ADDENDUM NO. 1 TO PROJECT NO. 45192

**ELEVATOR WORK, CONSTRUCTION WORK, HVAC WORK, PLUMBING WORK AND
ELECTRICAL WORK
REHABILITATE ELEVATOR, BUILDING NO. 82
GROVELAND CORRECTIONAL FACILITY
7000 SONYEA RD, RT. 36
SONYEA, NY**

December 12, 2016

MARK	DATE	DESCRIPTION
	DECEMBER 12, 2016	ADDENDUM NO. 1
	OCTOBER 14, 2016	BID DOCUMENT
PROJECT NUMBER: 45192 - C		
DESIGNED BY:		MTC
DRAWN BY:		PDD
FIELD CHECK:		MTC/PDD
APPROVED:		RAS
SHEET TITLE: REVISED DRAWING CONSTRUCTION FLOOR PLANS		
DRAWING NUMBER: A-102		
SHEET 13 OF 33

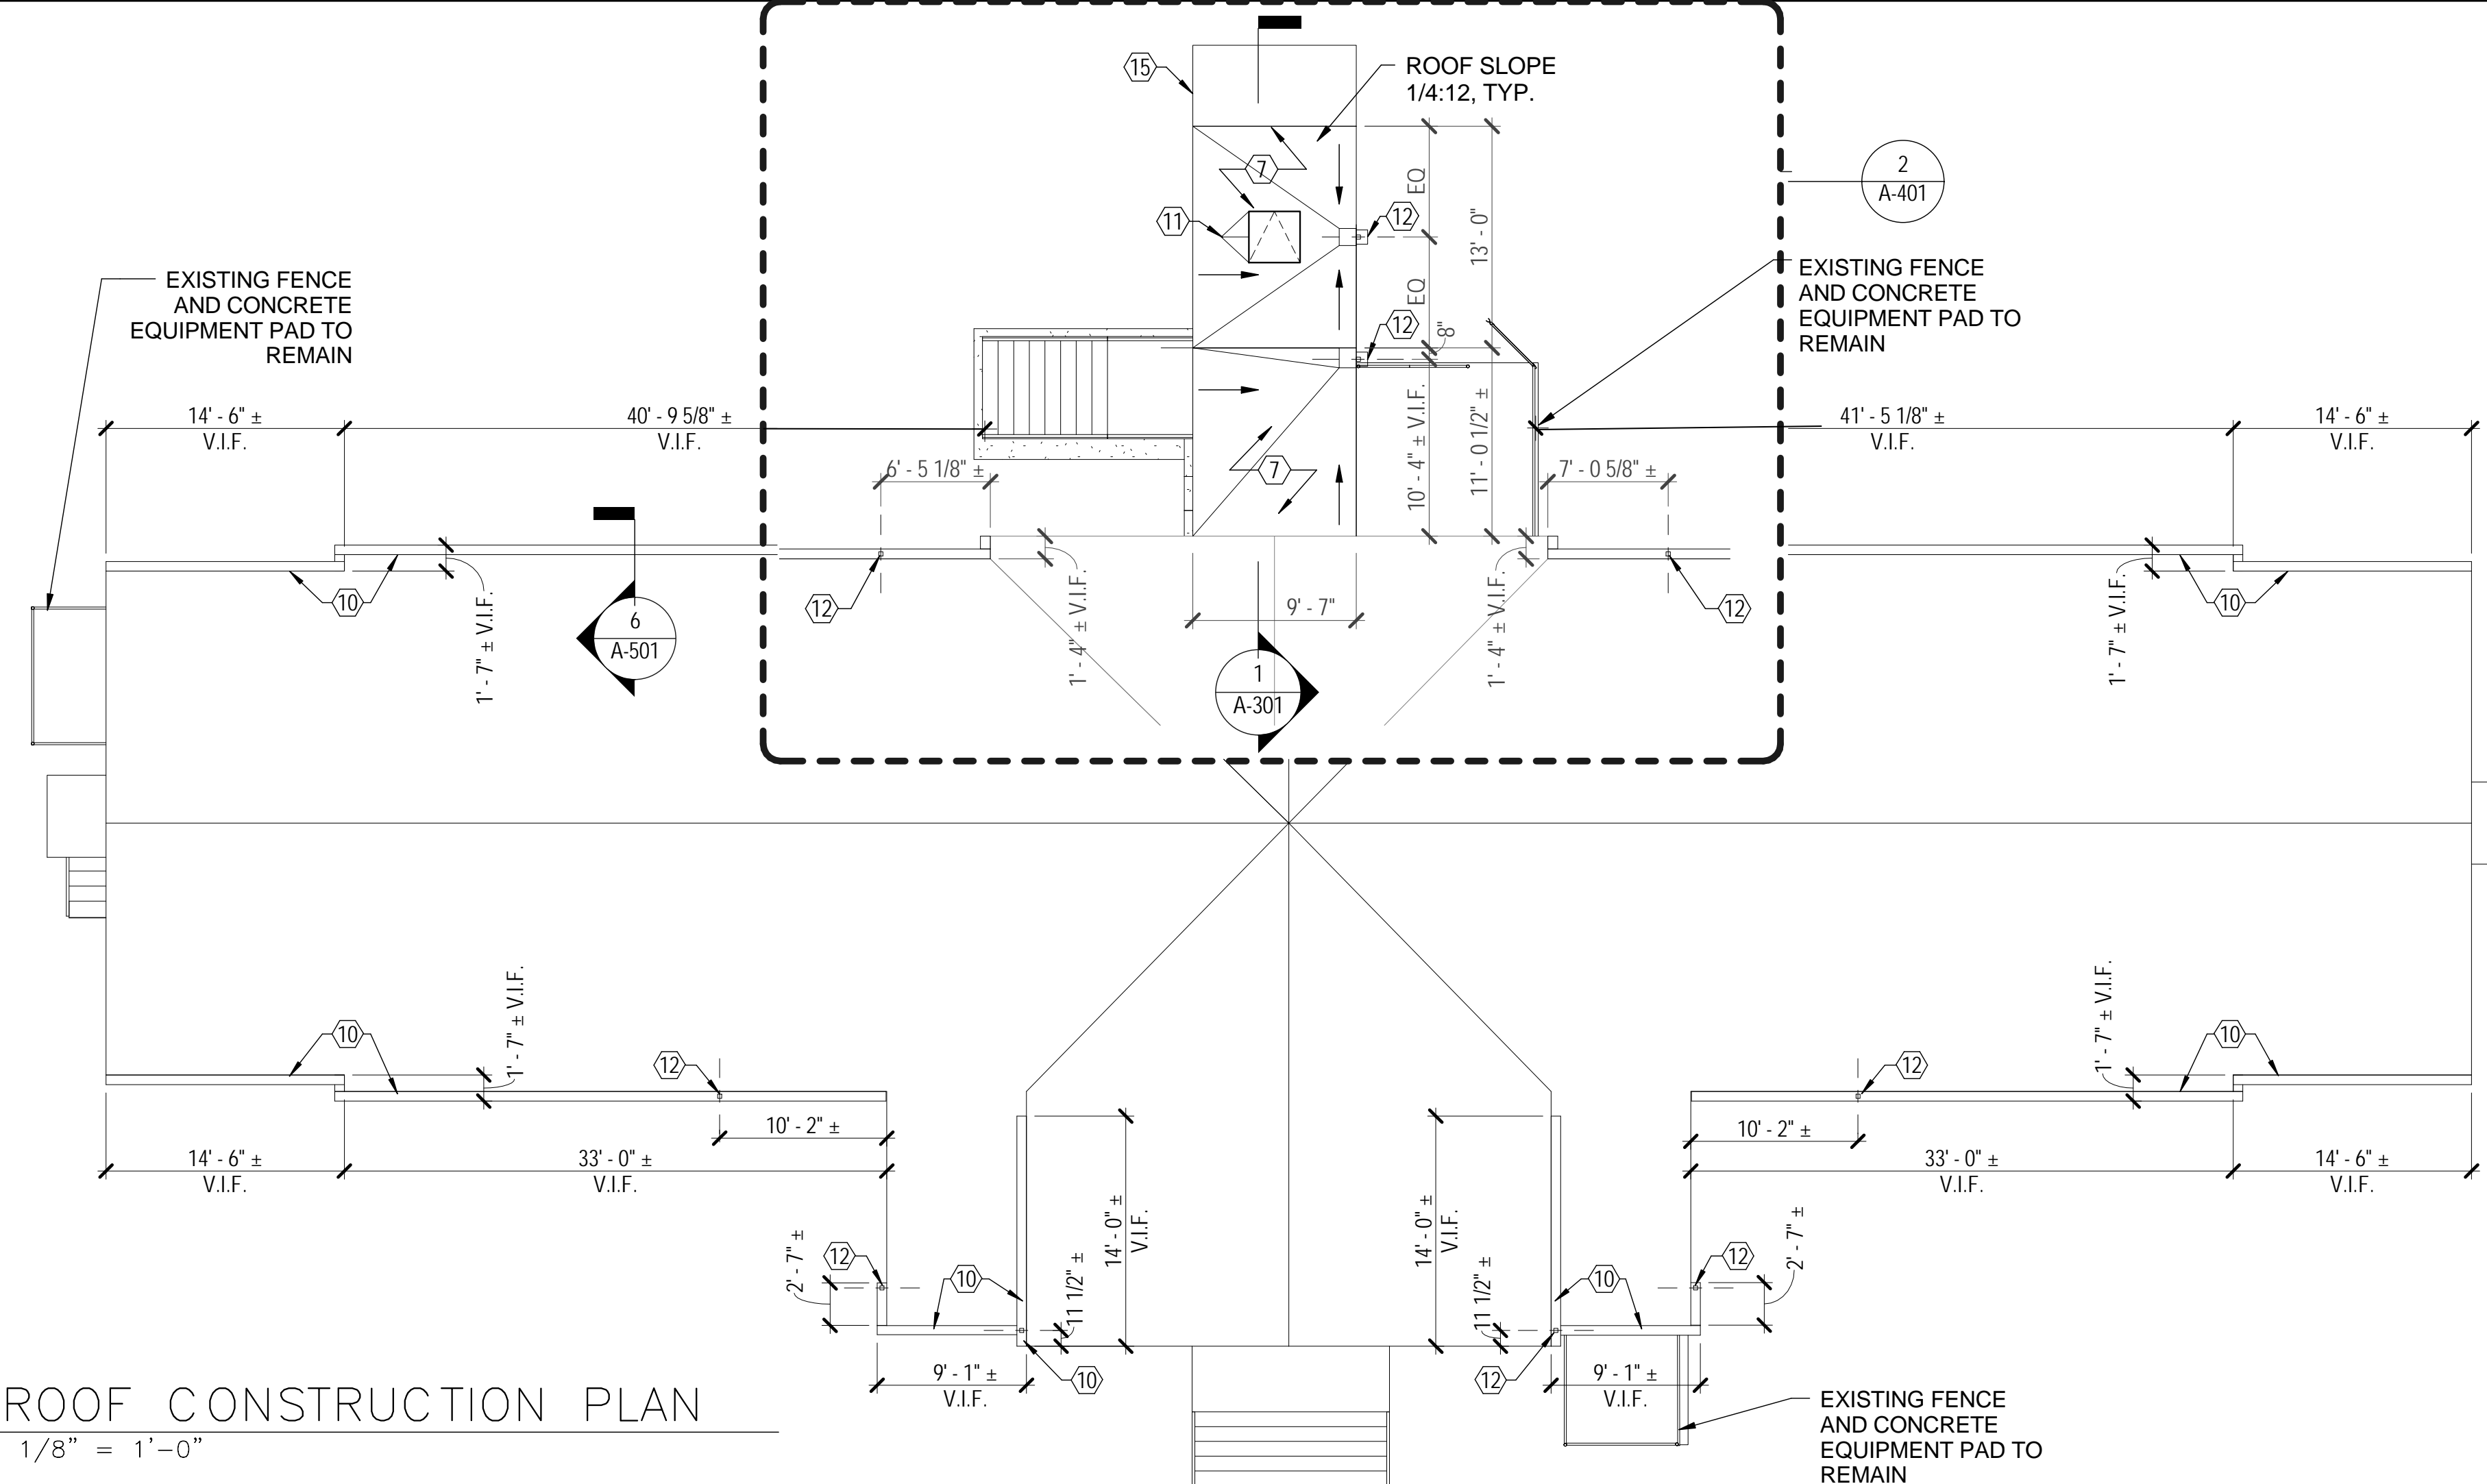
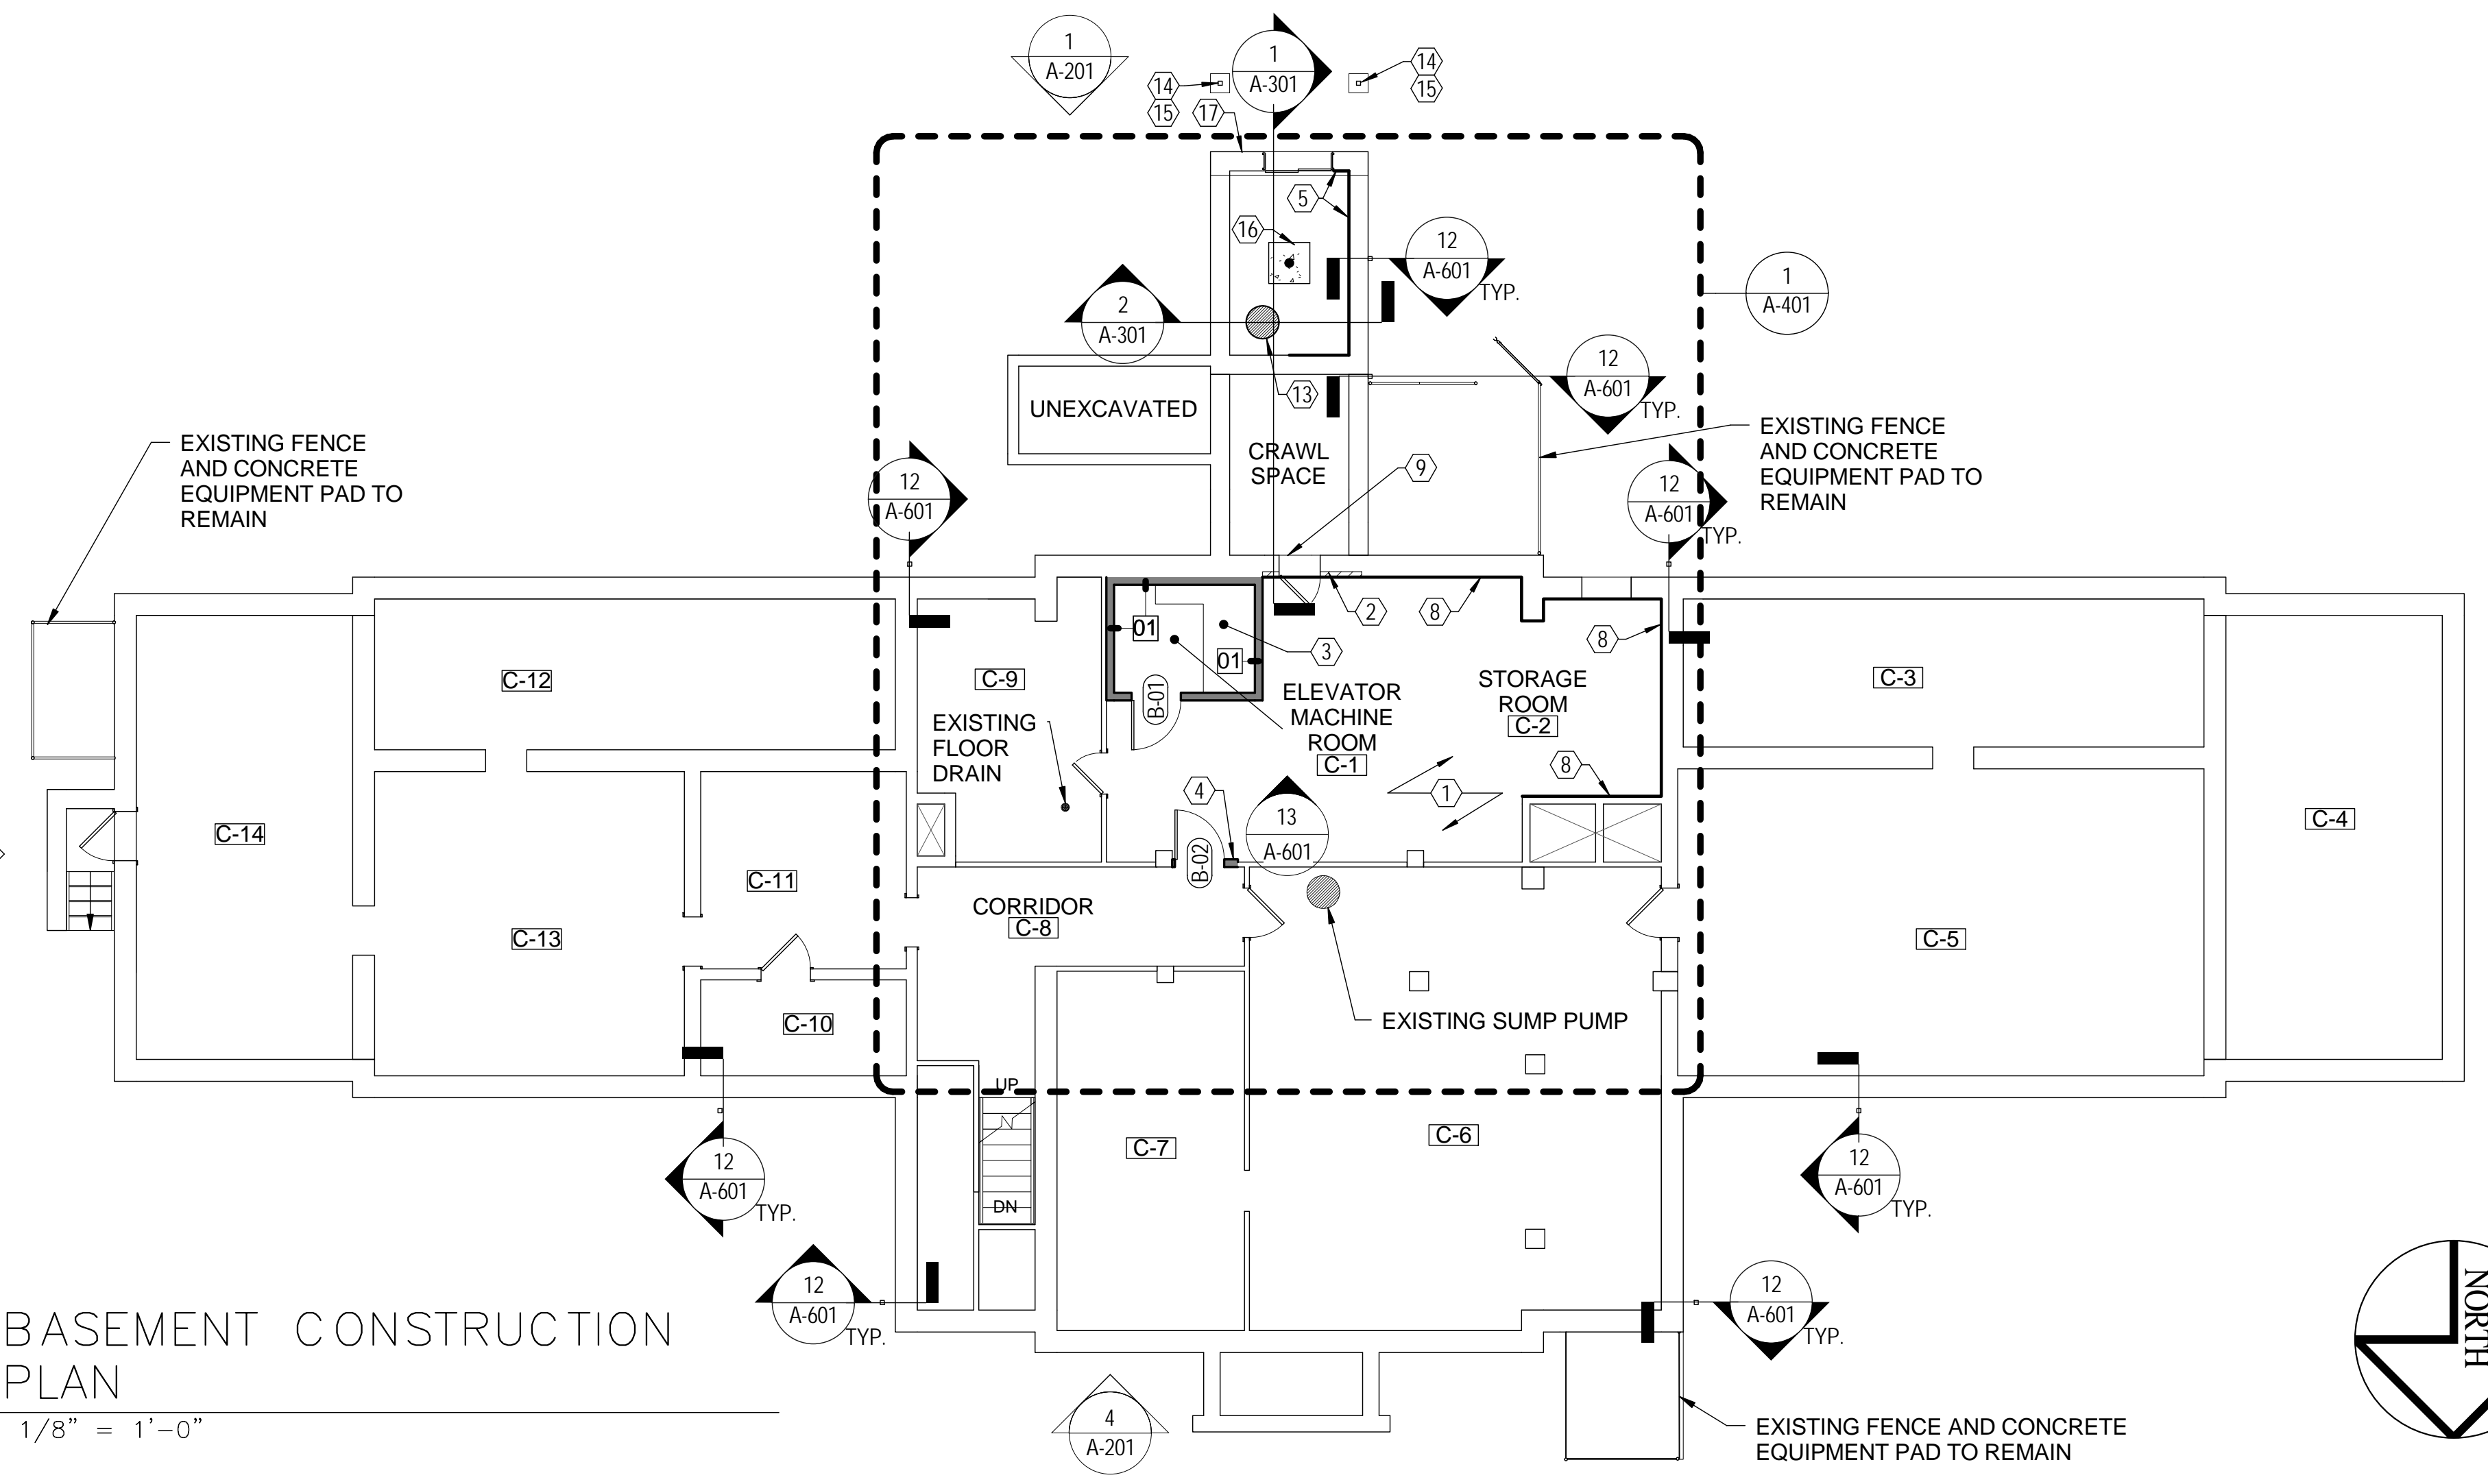
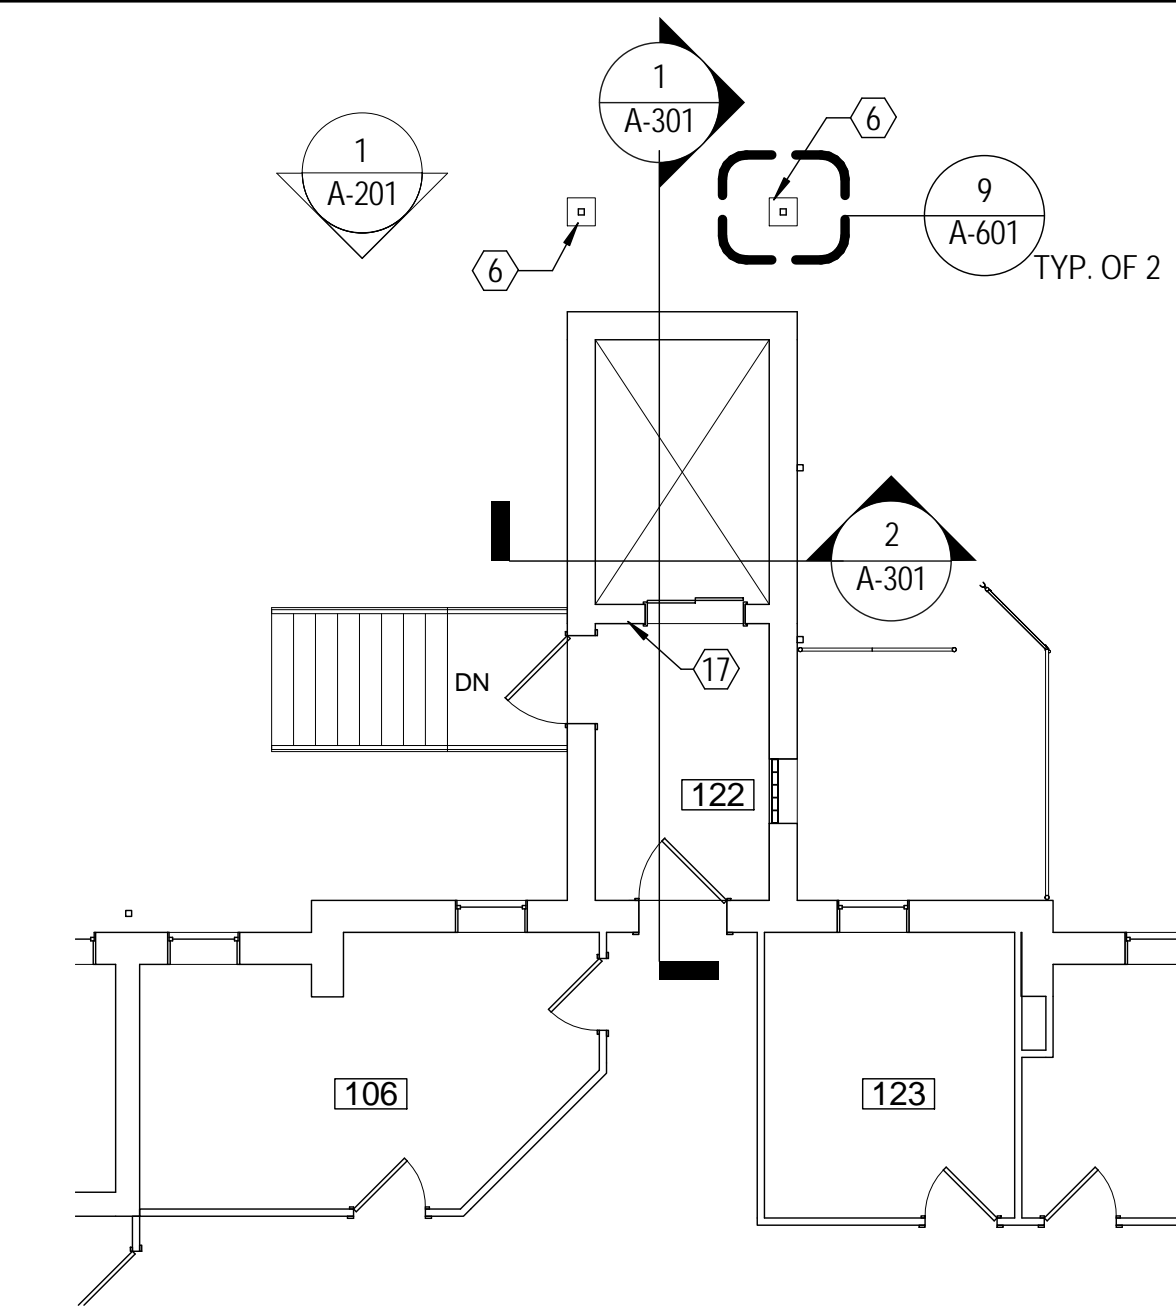
- PROVIDE BUILT-UP DEFLECTING CRICKET AT EXISTING HATCH. REFER TO DRAWING AA-01.
- PROVIDE 4"x3" ROOF LEADER WITH CLIMB GUARD. COORDINATE LOCATIONS WITH STORM SEWER PIPING - REFER TO ELEVATIONS & CIVIL DRAWING C-102 AND DETAILS 8/A-501 & 12/A-601.
